Shoreline Management and Pre-dredge Analysis

Public Meeting Update
November 12, 2016

Provide the Residents of Sunset Beach an
Opportunity to Review & Comment on Scope /
Design of Dredging Initiative

Potential Shoaling Impacts to AIWW, 'S' Curve, & Tubbs Inlet

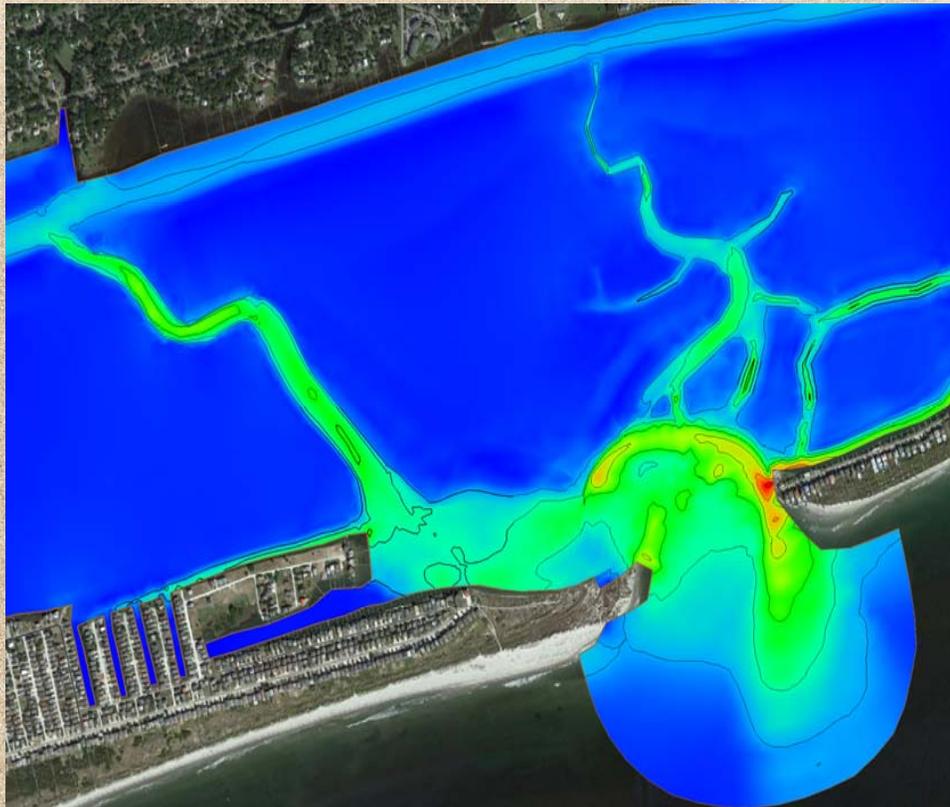
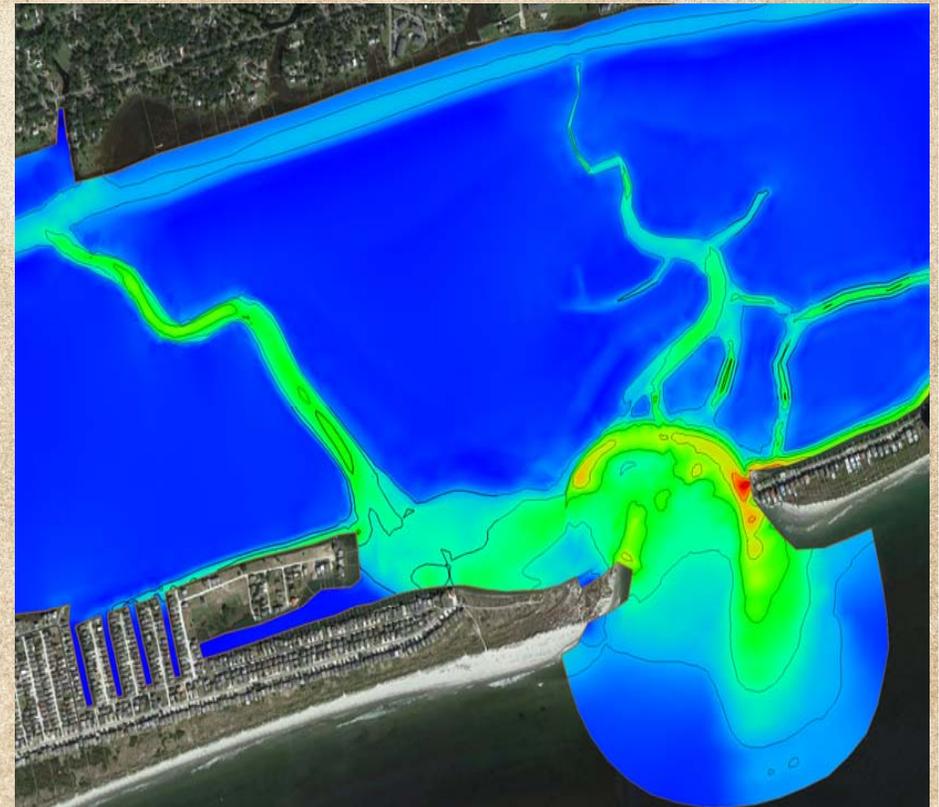
9. Regulations prohibit the contamination of waters on State Conservation Reserves such as Bird Island.
 - a) How will this dredging project affect the surrounding waters of the Bird Island Conservation Reserve on the west end of the island and Tubbs inlet on the south part of Jinks Creek?

The project is not anticipated to significantly change the tidal velocities or shoaling rates at Tubbs Inlet of Bird Island.

Jinks Creek

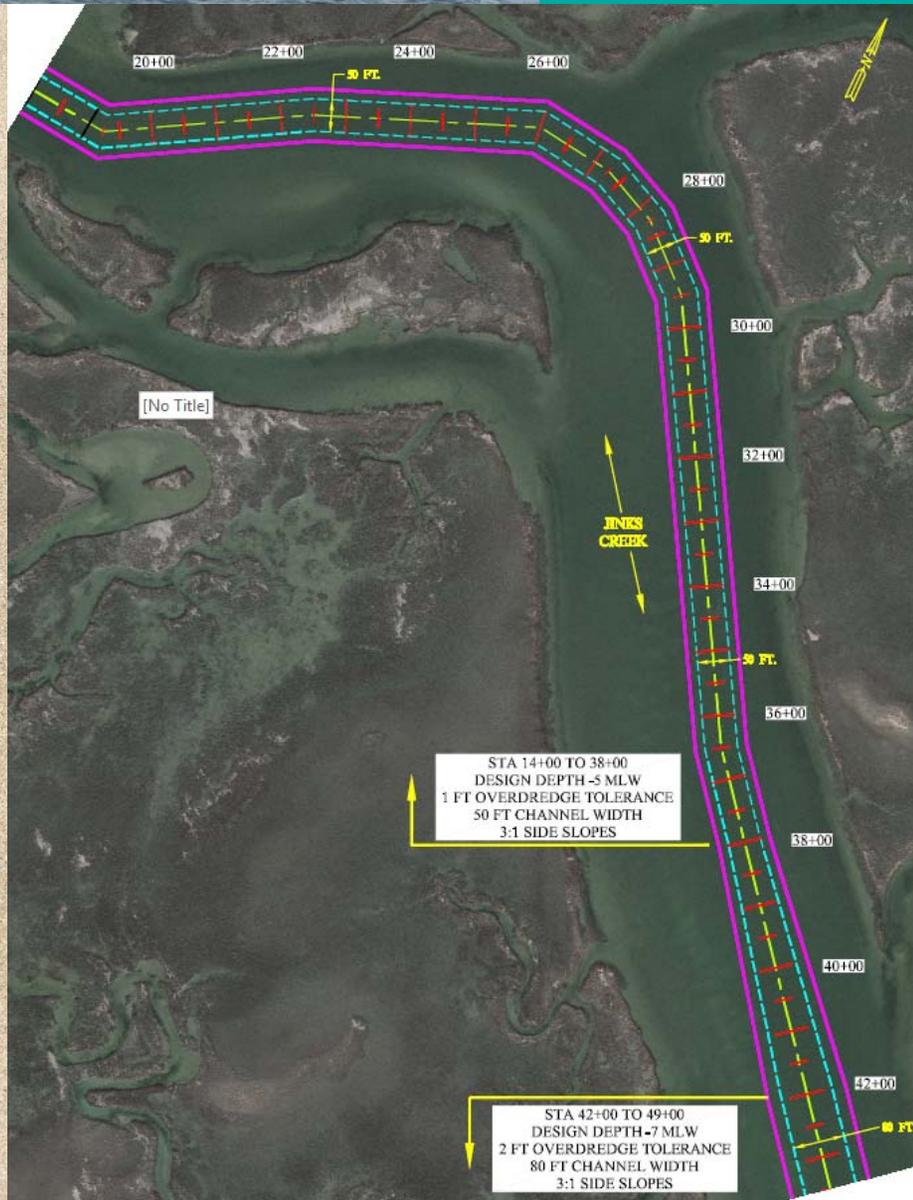
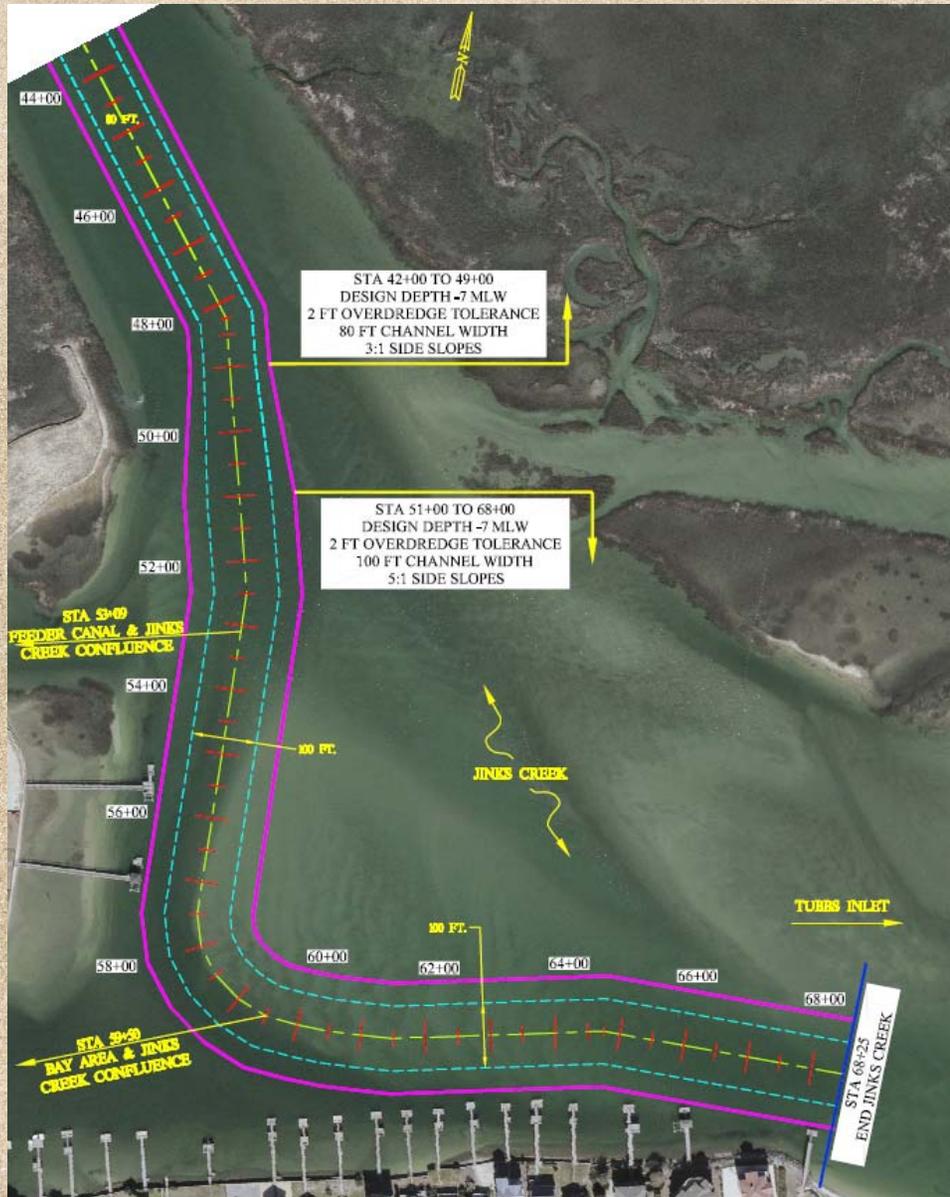
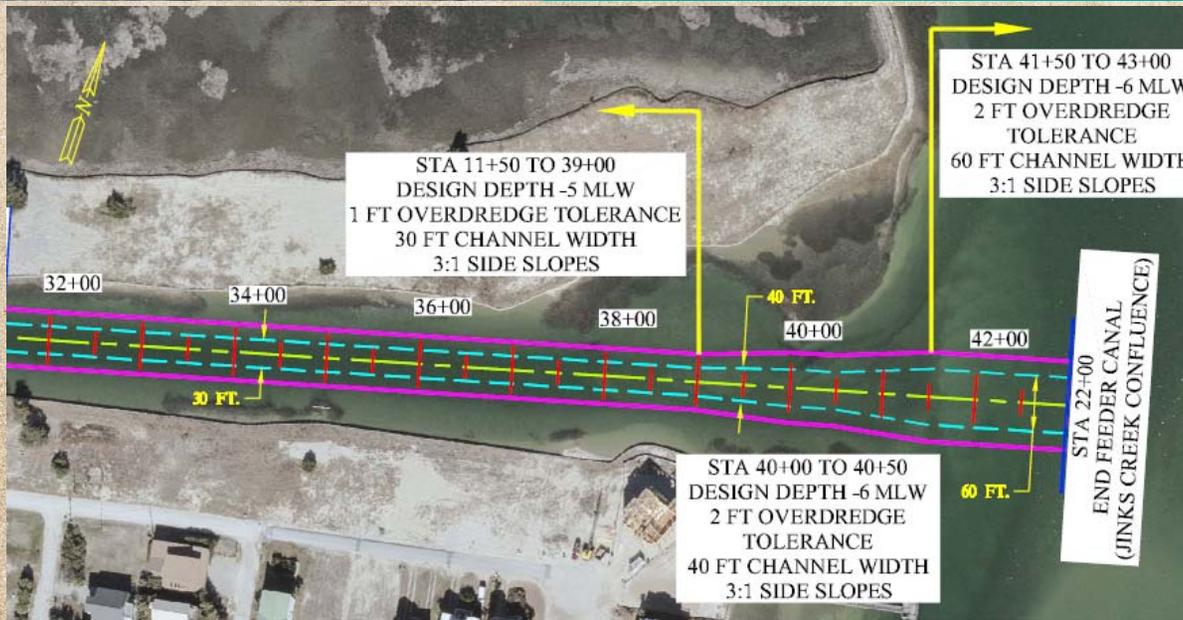
1. The March Scoping Application stated one of the reasons for the proposed dredging was to establish a navigable passageway through the canal.
 - a. Once Jinks Creek is -6 to -7 feet below mean low water, what size boat will be able to pass through Jinks Creek?
 - b. How will the wakes of these boats (recreational and commercial) change the impact of turbulence to the sediment and the shoreline?
 - c. How can we control the impact of these wakes?

2. Shallow water boats can enter the ICW from Jinks Creek at low tide.
 - a) What is the current depth of the proposed channel in North Jinks Creek?
 - b) What will be the future depth below mean low tide of the channel in North Jinks Creek?
 - c) Usually dredging is used for transportation purposes/economic value unless it is used for environmental purposes (which it is not in this case). If dredging is going to be used to increase the depth in this area, what is the point if it is not a navigational channel for international/national trade purposes? (Moffat and Nichol's Pre Dredge Analysis dated May 2, 2016, PAGE 9, Elevation Legend for Jinks Creek depth at present is -5 to -3 feet at mean low water. The design depth is -6 mean low water.)

7. The Moffat and Nichol report states that the four finger canals, A, B, C, D are presently -3 to -1 foot below mean low water and the design depth is -4 feet below mean low water.
 - a) Why is the Moffat & Nichol Proposal to dredge -6 feet below mean low water in Jinks Creek, when the canals can only support -4 feet without danger of bulkhead blow out?

- A. The dredge depths (-5 to -7 MLW) were chose as typical navigation depths based on similar projects within NC. Examples include the following:
 - Eastern Channel: -6 to -12 w. 0 ~ 2 ft OD tolerance (Navigation & Environmental Restoration)
 - Mason Inlet / Mason Creek: -6 MLW w/ 2 ft OD tolerance (Environmental Restoration)
- B. This could be a concern and some type of post construction monitoring is anticipated. The project is not proposed to create new navigation access, but rather to restore navigation access. However, a higher concentration of boaters could reasonably be expected. In similar projects the impacts were not observed (Mason Creek).
- C. If impacts occur some type of mitigation may be required. Enforcement may be an option but probably not an easy one unless vessels are operating at an unsafe speed.

- A. The controlling depth of Jinks Creek is approx. – 2 MLW.
- B. -5 MLW; however, shoaling is expected over time.
- C. Recreational navigation.

Expectations are Jinks Creek will shoal at a faster rate than the canals and additional usage will occur in Jinks Creek as compared to the finger canals. The additional depth is 'proposed' to account for these factors.
